Castle Street, Banbury

Flood Risk & Drainage Technical Note

Project No.	1260
Revision	D (Changes Highlighted)
Date	28 June 2022
Client	Churchill Retirement Living
Prepared	L Blackmore
Checked	C Yalden
Authorised	C Yalden
File Ref.	P:\1260 Castle Street, Banbury\C Documents\Reports\1260 - Castle Street, Banbury - Flood Risk & Drainage Technical Note - D

8 Summarised response to LLFA comments

PROJECT: CASTLE STREET, BANBURY
TITLE: PRELIMINARY DRAINAGE LAYOUT
CLIENT: CHURCHILL RETIREMENT LIVING
DRAWING STATUS: PLANNING APPLICATION

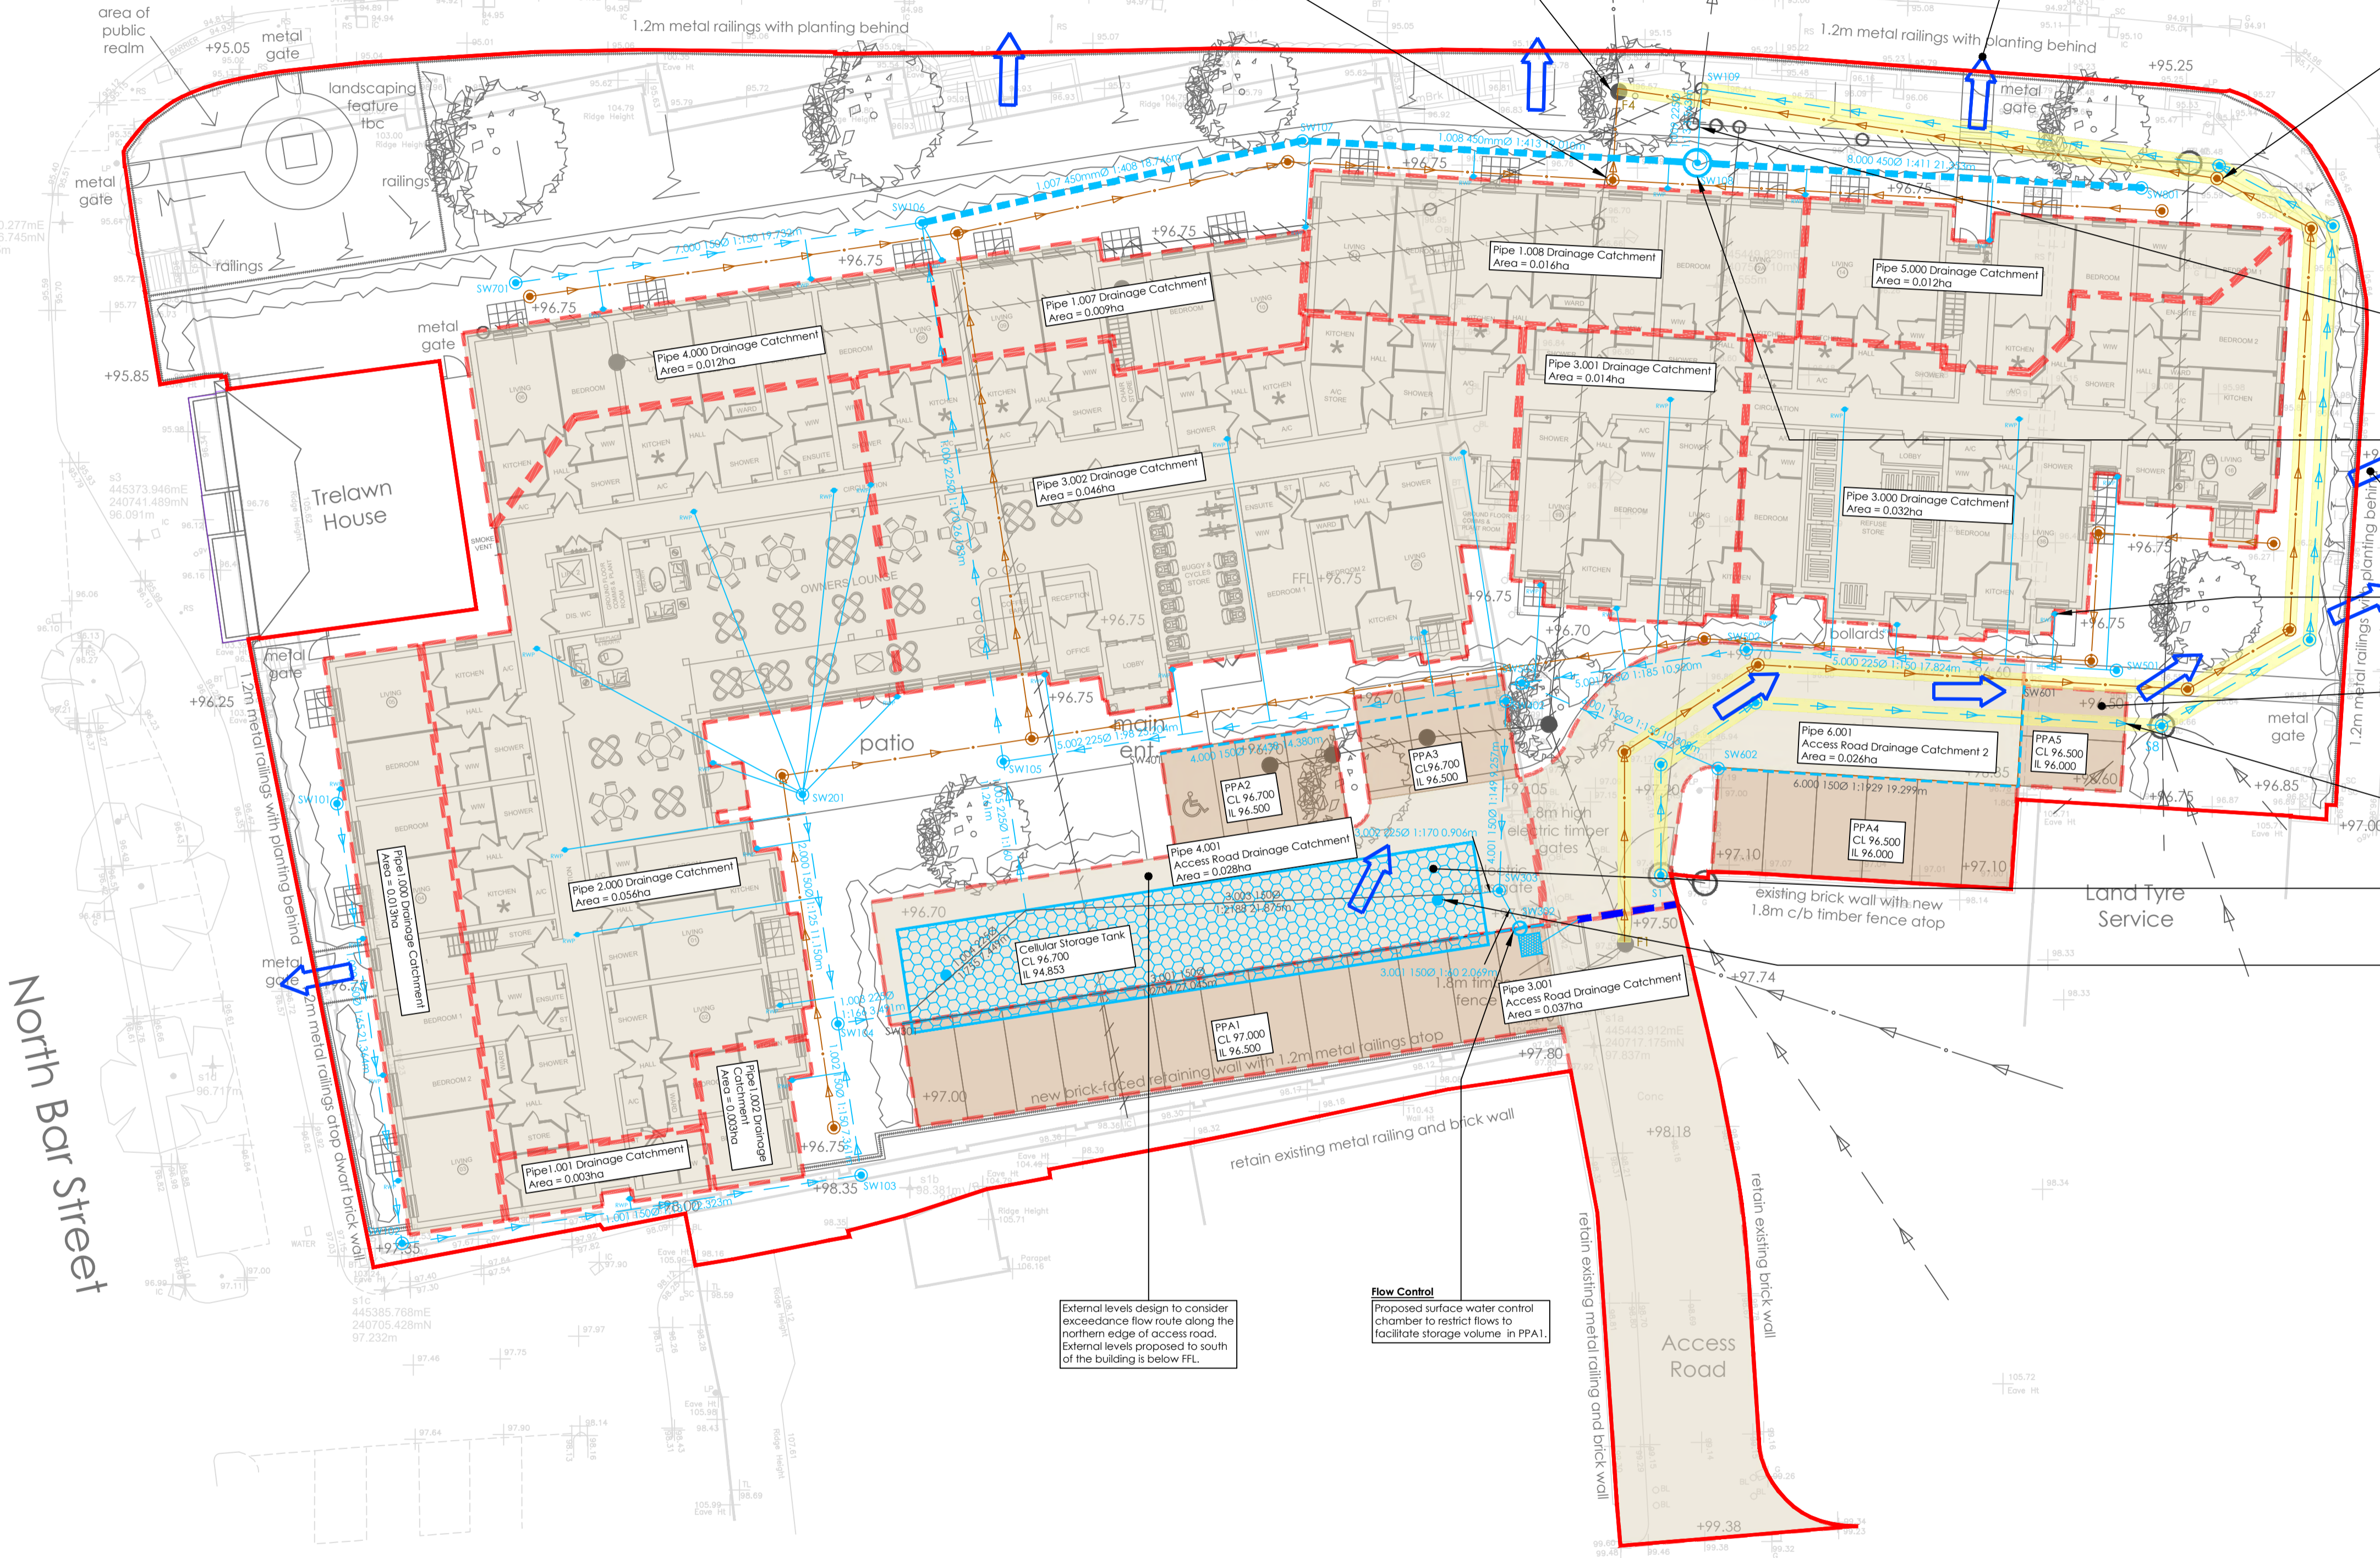
- 8.2 *Drainage strategy not detailed.* Surface water strategy now modelled as a Network (see Appendix G for details). Surface water network details included on the updated PDL drawing (Appendix H, Par. 4.15).

- 8.4 *Existing drainage not shown on the drainage strategy drawing.* All the existing drainage, to be abandoned, has now been included on the updated PDL (Appendix H).

- 8.5 *Remedial works for existing drainage pipes not identified on plan drawing.* Remedial work at point of connection with the surface water network now noted on the updated PDL (Appendix H).

- 8.12 *Drainage strategy drawing not detailed.* Surface water network details, now including cover and invert levels for attenuation features included on the updated PDL drawing (Appendix H). Surface water strategy network model updated to suit most up to date levels with modelling output provided in Appendix G.

- 8.13 *Surface water catchment plan.* The surface water catchments are shown on the PDL drawing (Appendix H). The total area drained is 0.308ha as stated in the PDL summary notes. Individual catchment areas have been annotated, together with which pipe they are draining to in the network model. It should be noted that some pipe runs receive flow from multiple areas. The text has been made clearer on the PDL drawing.

As part of a full application drawings and calculations are expected to be detailed. Drainage strategy drawing should show invert and cover levels for all proposed drainage infrastructure and SuDS feature. All surface water pipes needs to be numbered and sized which should correlate with the Microdrainage calculations. Calculations required for the whole surface water network.

Existing drainage to be shown on drainage strategy drawings. Existing pipes that are being retained should be clearly identified. Also all the maintenance requirements for the existing retained pipes needs to be identified on plan drawings.

As part of a full application drawings and calculations are expected to be detailed. Drainage strategy drawing should show invert and cover levels for all proposed drainage infrastructure and SuDS features. Attenuation tank and permeable paving details not provided. The tank and permeable paving details should reflect the calculations.

Surface water catchment plan required to demonstrate how the site will drain and to which drainage features. The proposed areas needs to be clearly shown and the existing areas. The impermeable area on the catchment plan is different to the area used in the calculations. Please clarify. The catchment plan should also show the area going into the proposed surface water network.

Surface water exceedance plan to be provided to demonstrate how the site will drain in an event where the surface water network fails. All surface water should be kept away from structures and within the site boundary, currently some of the flow arrows shows surface water leading outside the side boundary. How is the surface water being picked up in these areas.

External levels design to consider exceedance flow route along the northern edge of access road. External levels proposed to south of the building is below FFL.

Flow Control
Proposed surface water control chamber to restrict flows to facilitate storage volume in PPA1.

PROJECT:	CASTLE STREET, BANBURY		
TITLE:	PRE-DEVELOPMENT IMPERMEABLE AREAS PLAN		
CLIENT:	CHURCHILL RETIREMENT LIVING		
DRAWING STATUS:	PLANNING APPLICATION

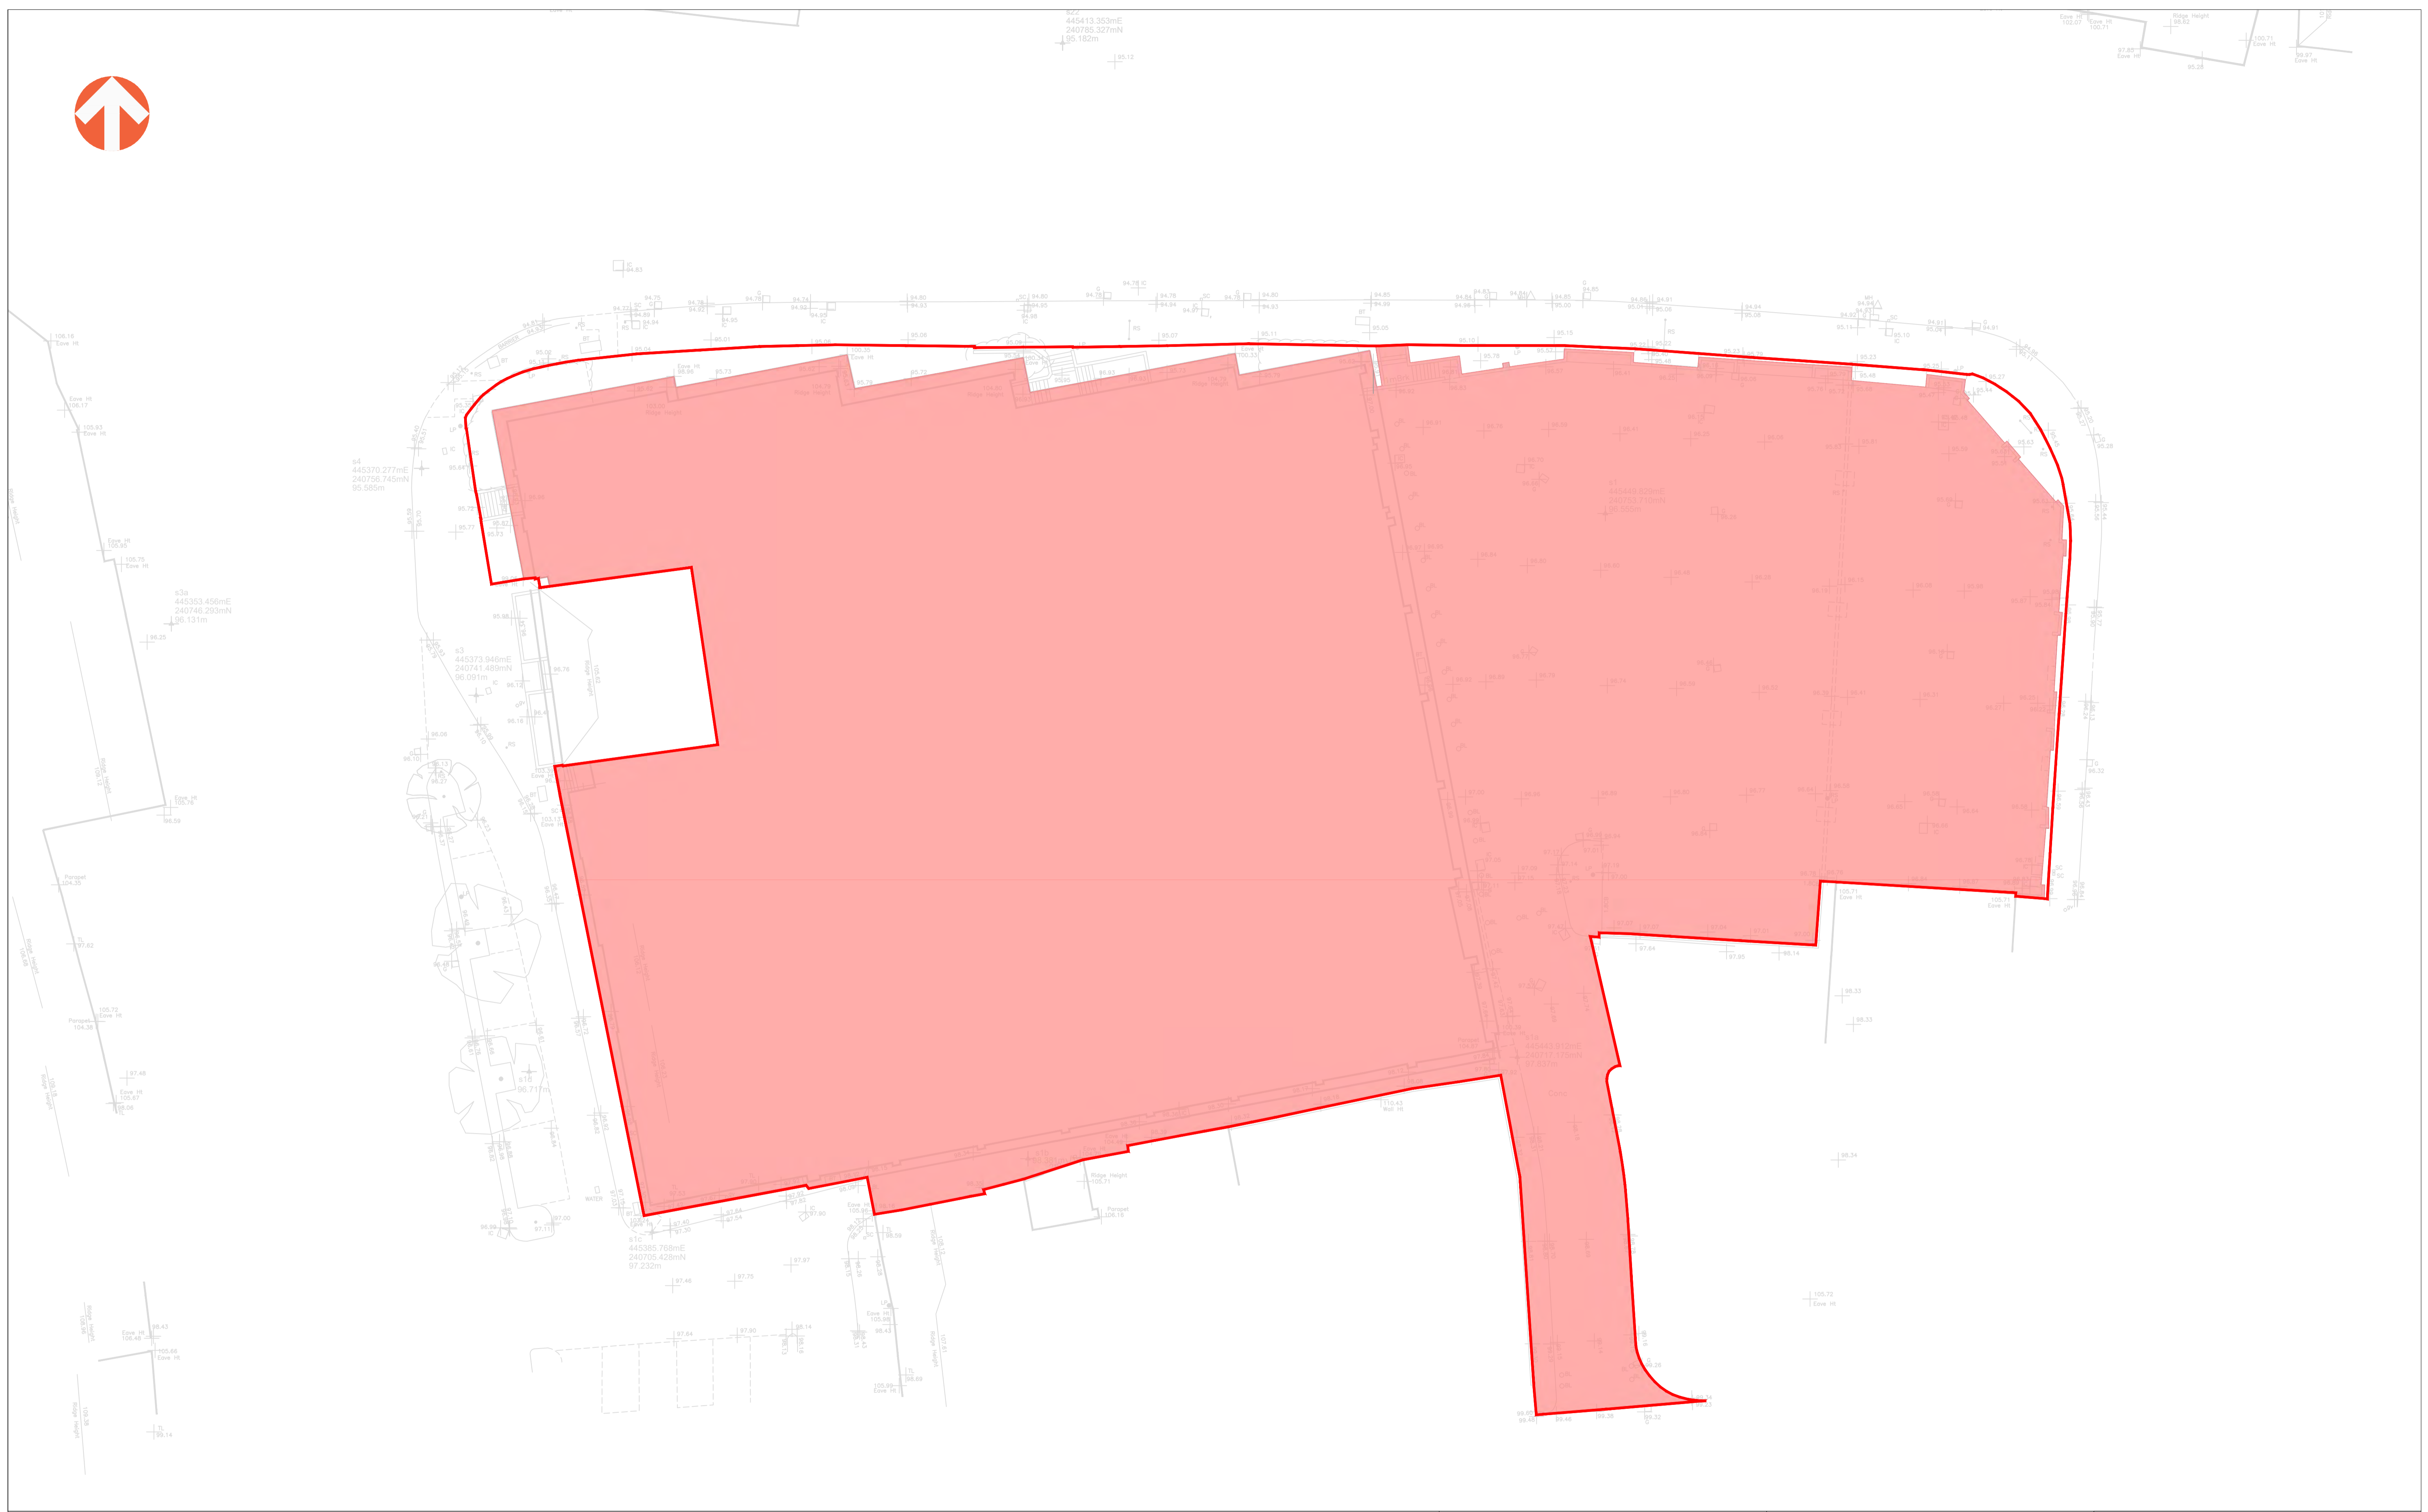
- 8.6 *Surface water catchment plan not provided.* An 'Existing Impermeable Area' plan has now been provided (Appendix I). The impermeable catchment areas for the proposed development are now indicated on the updated PDL (Appendix H).

Surface water catchment plan required to demonstrate how the site will drain and to which drainage features. The proposed areas needs to be clearly shown and the existing areas.
